ADDENDUM NO. 2

March 24, 2021

Additions & Renovations to Pleasant Run Elementary School 1800 North Franklin Road Indianapolis, IN 46219

TO: ALL BIDDERS OF RECORD

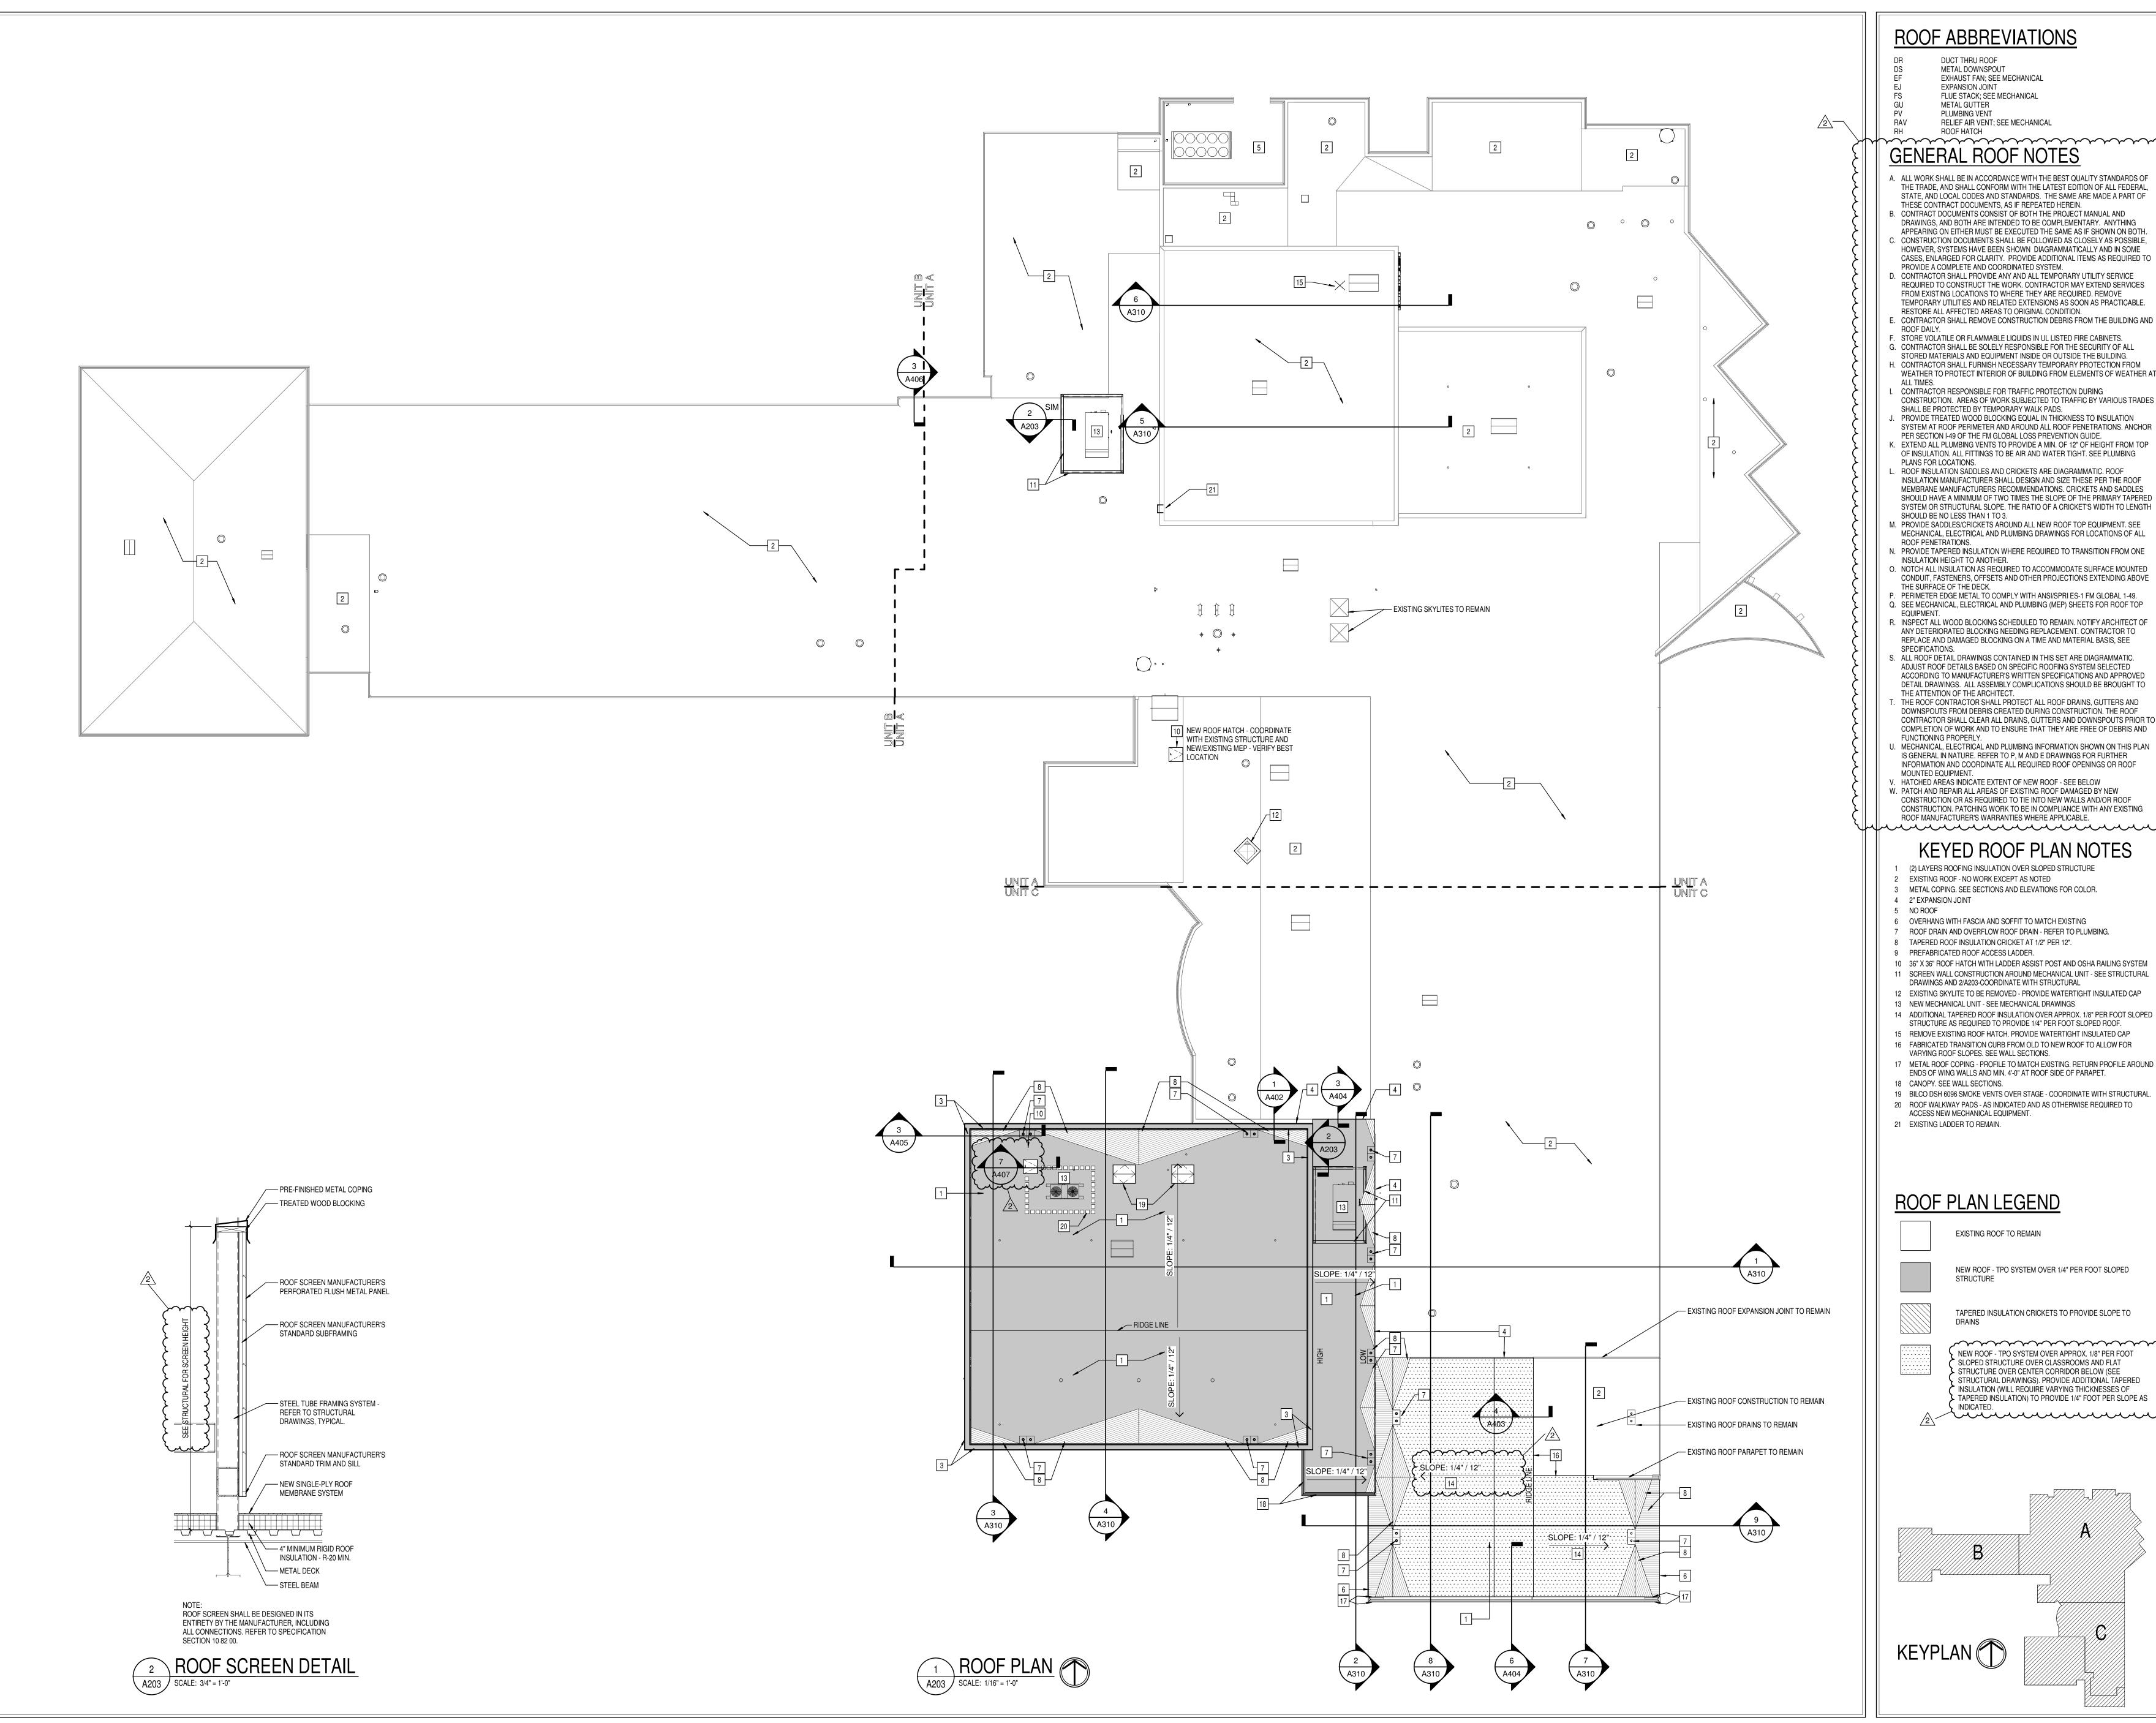
- 10 36" X 36" ROOF HATCH WITH LADDER ASSIST POST AND OSHA RAILING SYSTEM 11 SCREEN WALL CONSTRUCTION AROUND MECHANICAL UNIT - SEE STRUCTURAL
- DRAWINGS AND 2/A203-COORDINATE WITH STRUCTURAL 12 EXISTING SKYLITE TO BE REMOVED - PROVIDE WATERTIGHT INSULATED CAP

DRAWING NUMBER C101

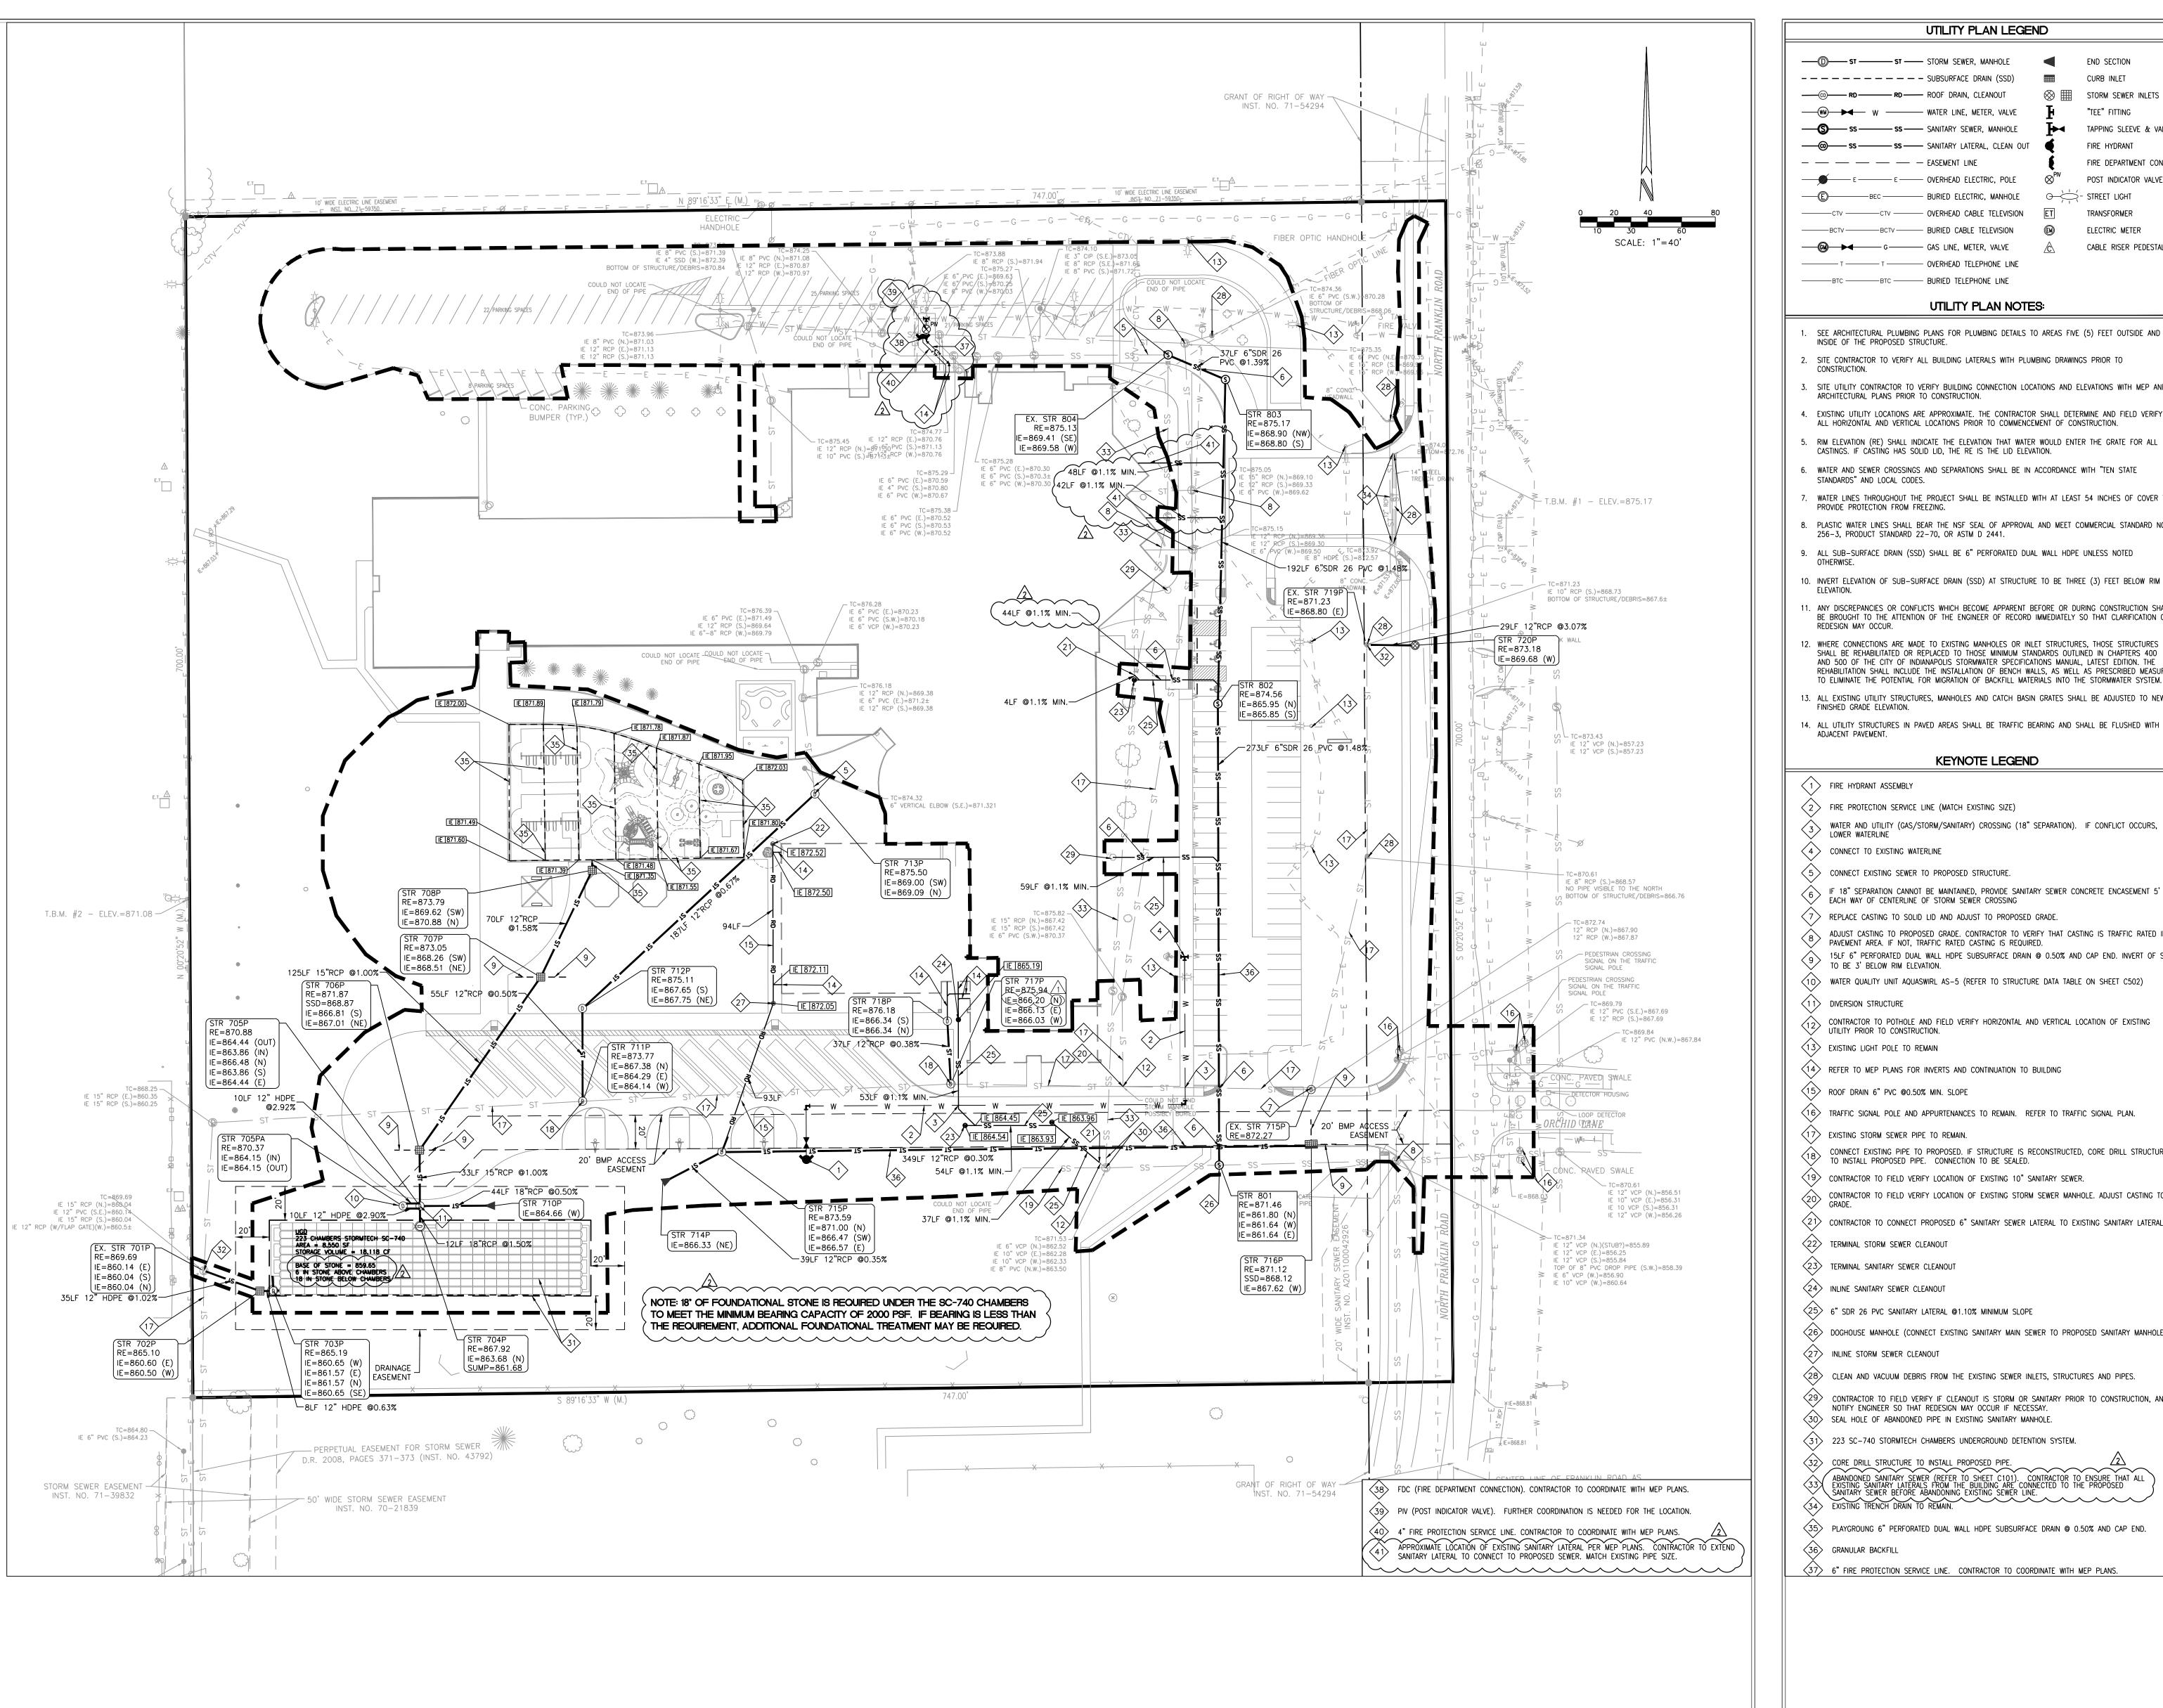
- 1. C101 Existing Conditions and Demolition Plan
 - a. Revise keynote 38.
 - b. Add leader with keynoter 45.
- 2. C501 Utility Plan
 - a. Revise stone below the chambers to 18 inches.
 - b. Revise base of stone elevation to 859.65.
 - c. Revise keynotes 33.
 - d. Add keynote 41.
 - e. Swap the location of the FDC and the PIV with the fire lines respectively.
- 3. C504 Utility Details
 - a. Revise detail information.
 - b. Revise notes.
- 4. L500 Site Details
 - a. Details 1, 2, 4, and 6 have been updated to reflect the recommended paving thicknesses per the geotechnical report.
- 5. Traffic Signal Modernization
 - a. Replace Current Sheet with the Attached.
